THM 700-R4 "UPDATE HANDBOOK"

AUTOMATIC TRANSMISSION SERVICE GROUP

Figure 24

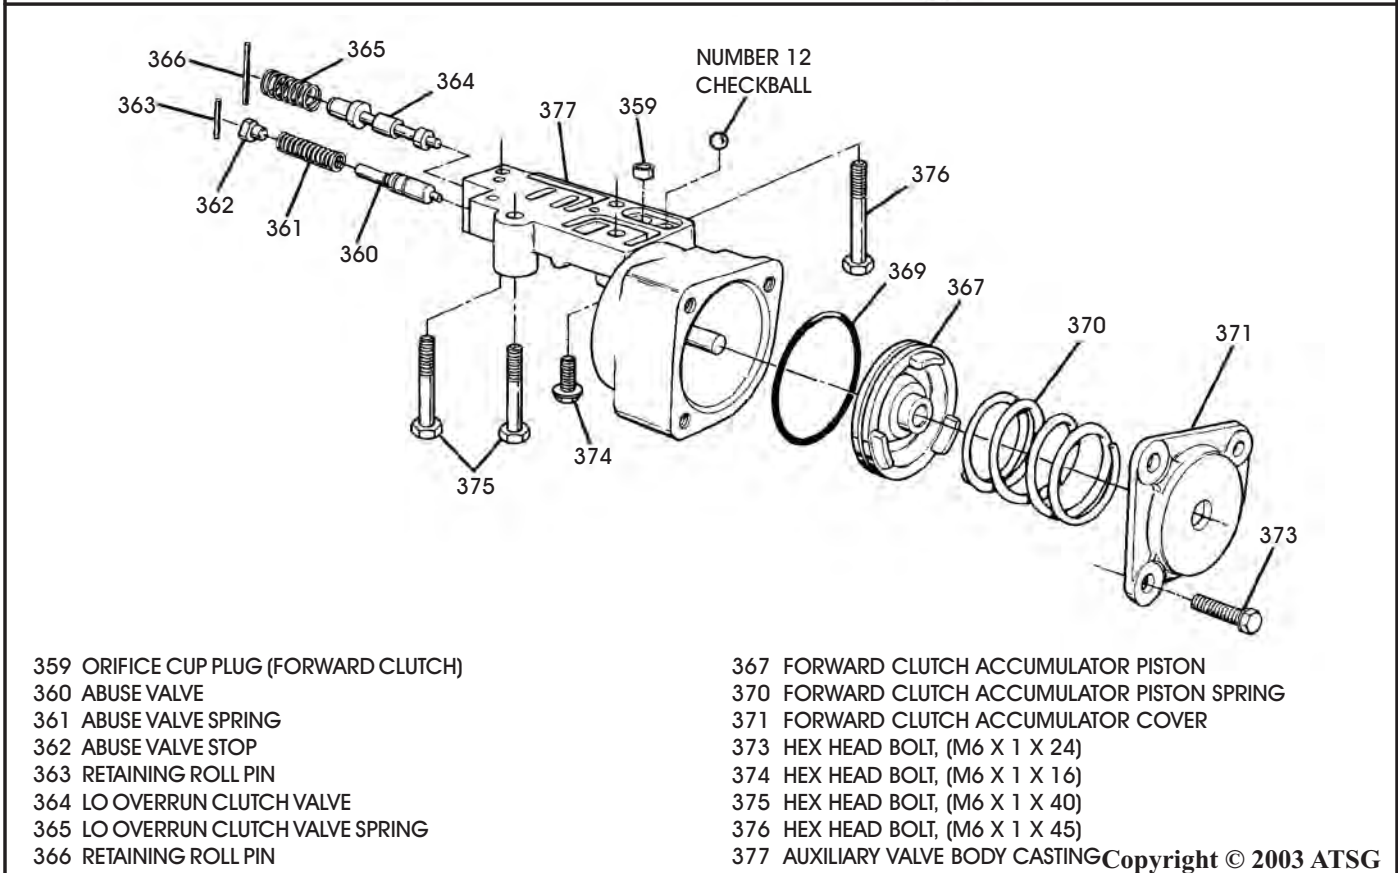
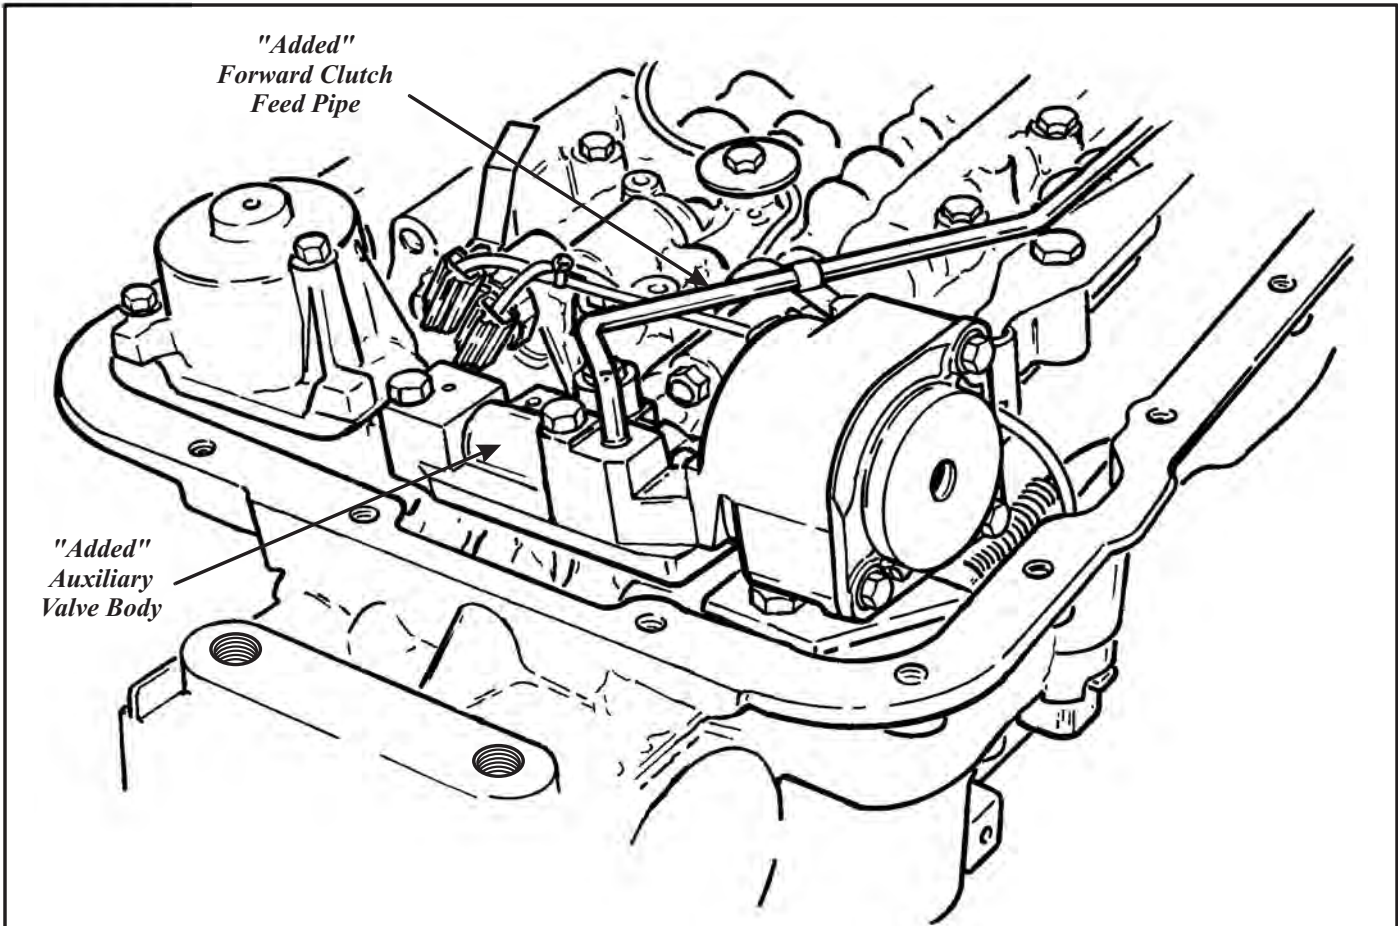
CHANGE: Beginning on July 17, (Julian Date 198) 1986, *some* 1987 model THM 700-R4 transmissions were built with an "Added" Auxiliary Valve Body. By October 6, (Julian Date 279) all 1987 model THM 700-R4 transmissions were built with the added Auxiliary Valve Body, as shown in Figure 24.

- (1) **AUXILIARY VALVE BODY** - Added as per dates listed above and performs the following:
 - (a) The Low Overrun Valve in the auxiliary valve body provides a smooth 2-1 Manual downshift. It also regulates the pressure applied to the Low/Reverse clutch to a lower pressure (See Figure 24).

- (b) The Abuse Valve in the auxiliary valve body, shown in Figure 24, protects the forward clutch during rock cycles. Rock cycles are defined as rapidly shifting the transmission back and forth between Reverse and Drive when the vehicle is stuck in mud, sand, snow or ice. At any throttle position higher than idle, the Abuse Valve opens to by-pass the new forward clutch feed orifice cup plug located in the auxiliary valve body. This results in a quicker forward clutch apply time. A quicker apply produces less heat and increases clutch durability.

- (c) A Forward Clutch Accumulator Piston and Spring are incorporated in the new auxiliary valve body, as shown in Figure 24, and provides smoother garage shifts to Drive.

- (2) **TRANSMISSION CASE** - Total of four changes and they are as follows:
 - (a) The case has a "Rib" added to the worm track area at the rear, in the low/reverse passage, as shown in Figure 25.

- (b) The case has a cast, pipe window, added in the front center, as shown in Figure 25, to allow an added forward clutch feed pipe to be inserted into the forward clutch feed hole in the oil pump cover (See Figure 25).

- (1) *"Do Not"* install the number 5 check ball in the main valve body on any 1987 and later model THM 700-R4 transmission, that uses the Auxiliary Valve Body (See Figure 28).
- (2) The 1987 case can be used on 1982-1986 models, but you *Must* do the following:
 - (a) Remove the added RIB in the low/reverse case passage with a die grinder (See Figure 25).
 - (b) Drill the forward clutch feed passage in the face of the pump bore, using a 21/64" drill bit. Refer to Figure 26.

Figure 29

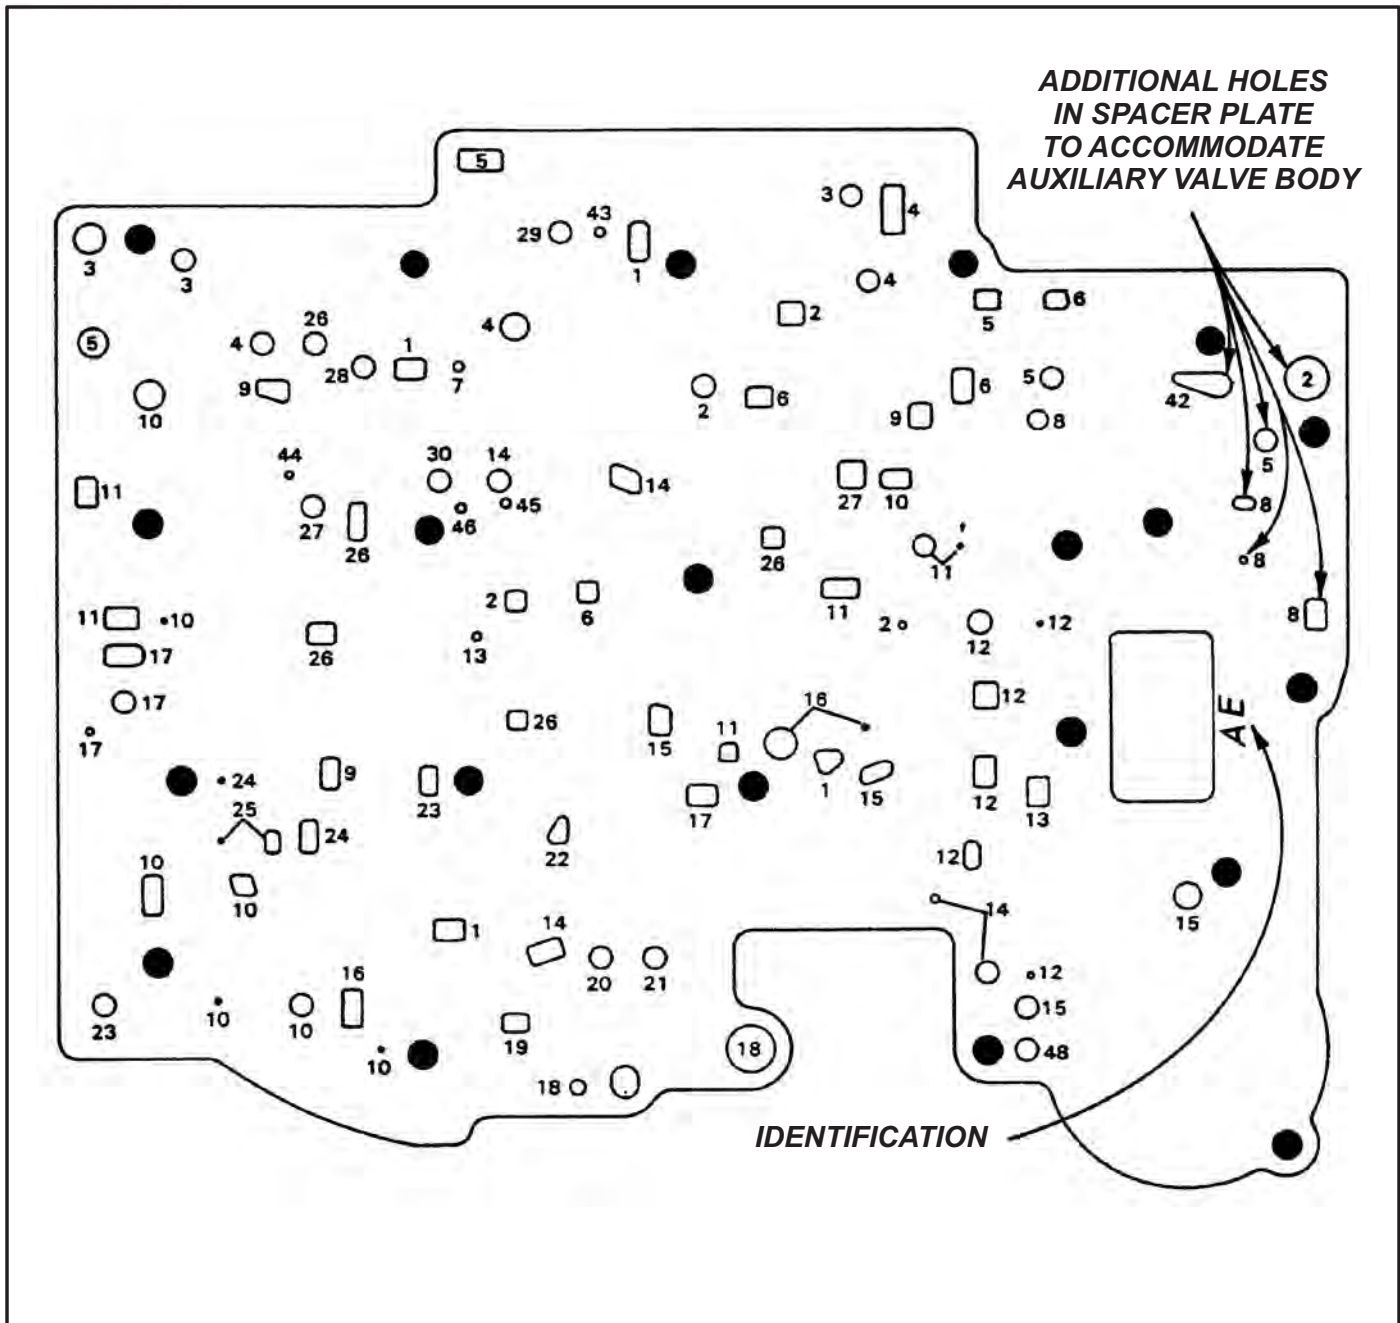
- (4) **VALVE BODY SPACER PLATE** - Several holes were added to the spacer plate to accommodate the added auxiliary valve body, and there is now a "Two" letter identification code stamped into all 1987 and later spacer plates, as shown in Figure 29.

Figure 37

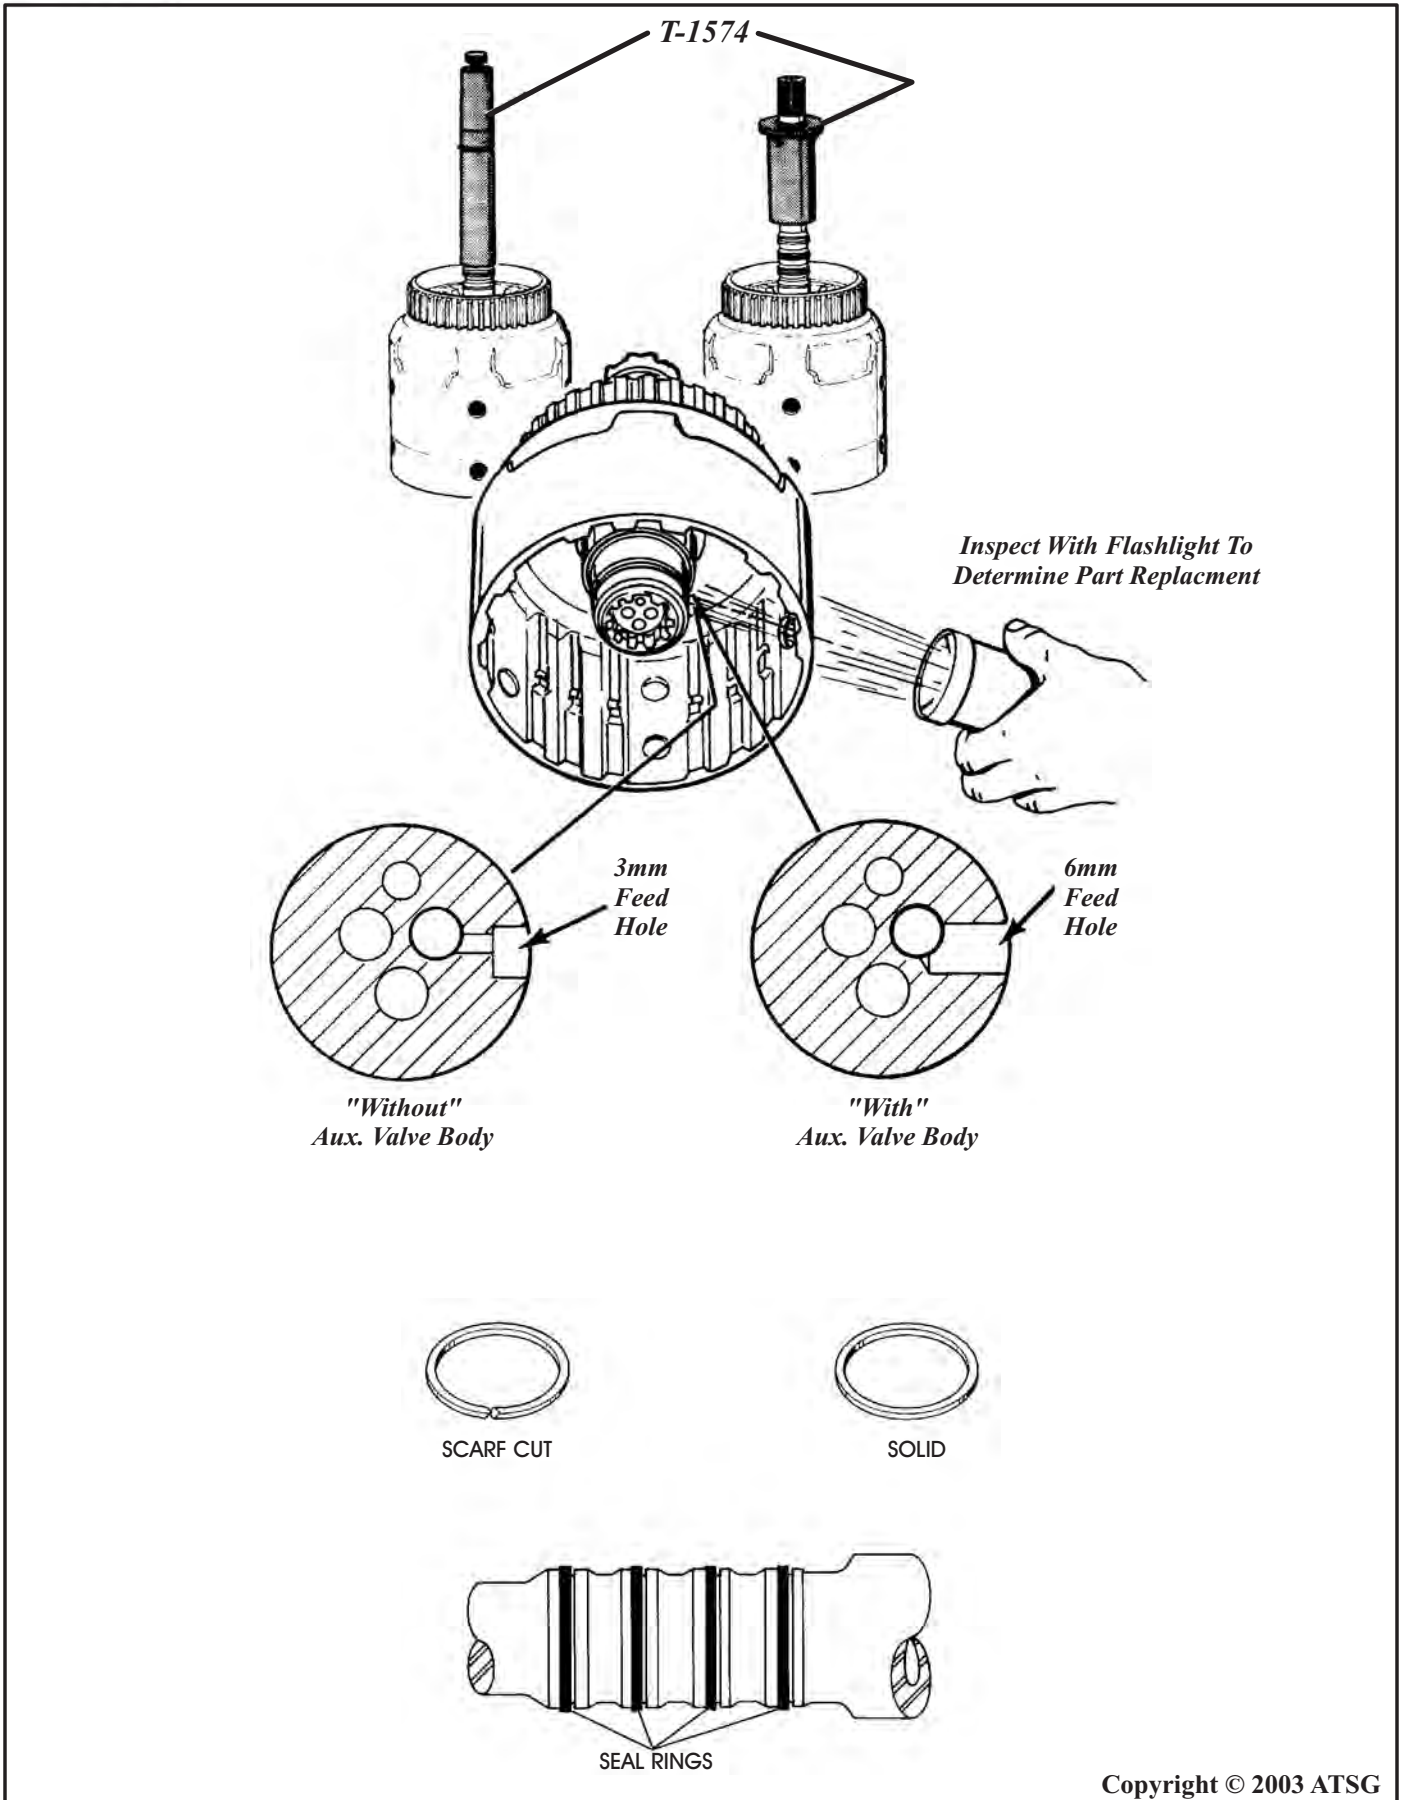
- (b) The turbine shaft seals are now solid Teflon, instead of the previous scarf-cut seals. The solid turbine shaft seals require an installation and resizing tool, as shown in Figure 37, and is available under part number T-1574.

- (6) **"Always"** check the turbine shaft in the input housing assembly using a flashlight, as shown in Figure 37, for an orifice in the forward clutch feed passage.

- (a) Using a 1987 or later input housing **without** this orifice in 1982-1986 models, will result in a very harsh garage shift into drive (See Figure 37)

Figure 38

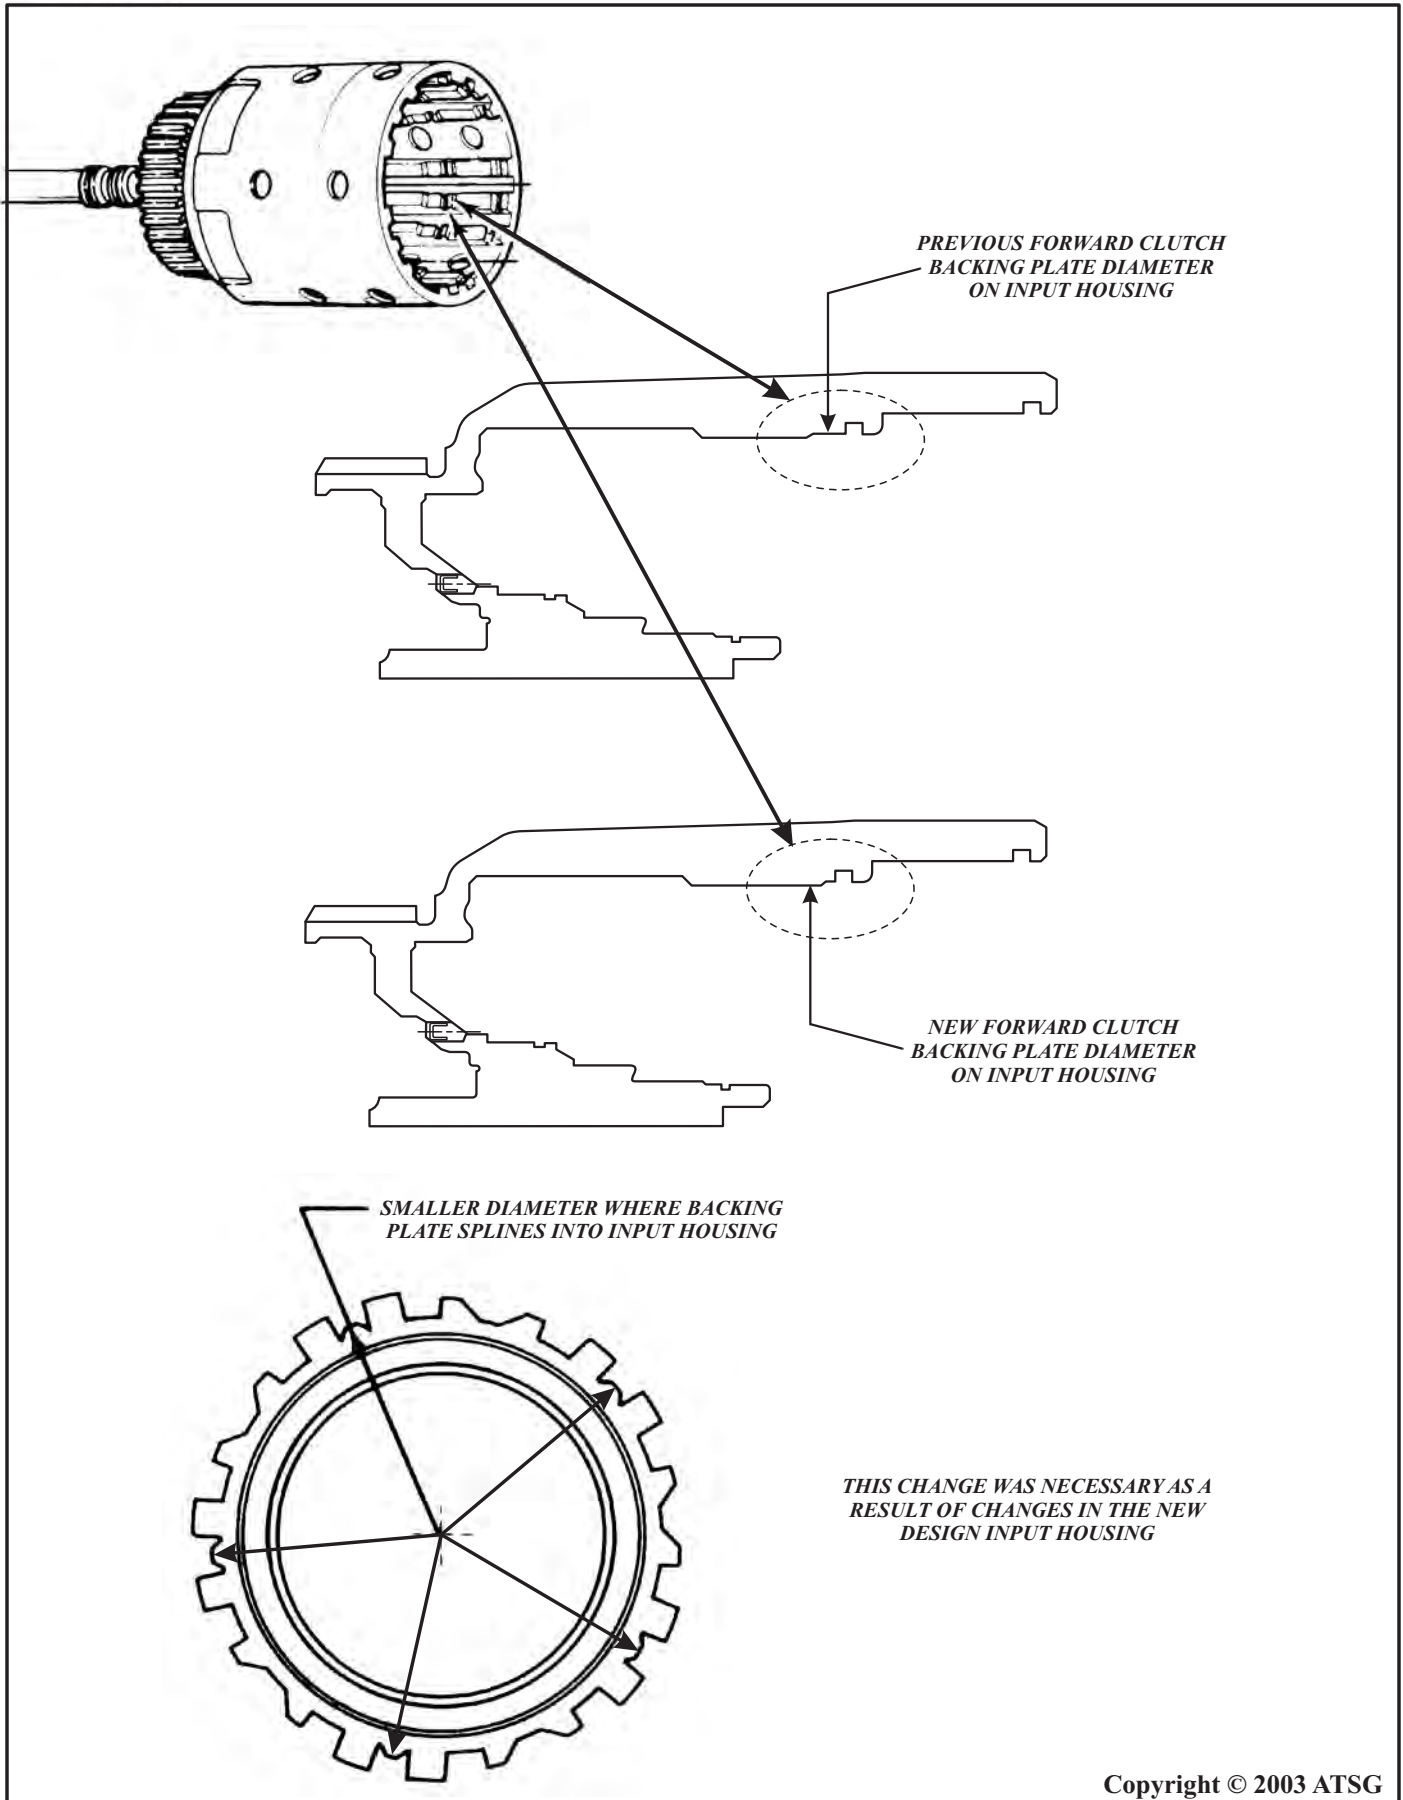
- (c) The Input Housing has a smaller diameter where the backing plate splines into the input housing, and is illustrated in Figure 38. The new design forward backing plate also has a smaller pilot diameter to accommodate the changes in the input housing, as shown in Figure 38.
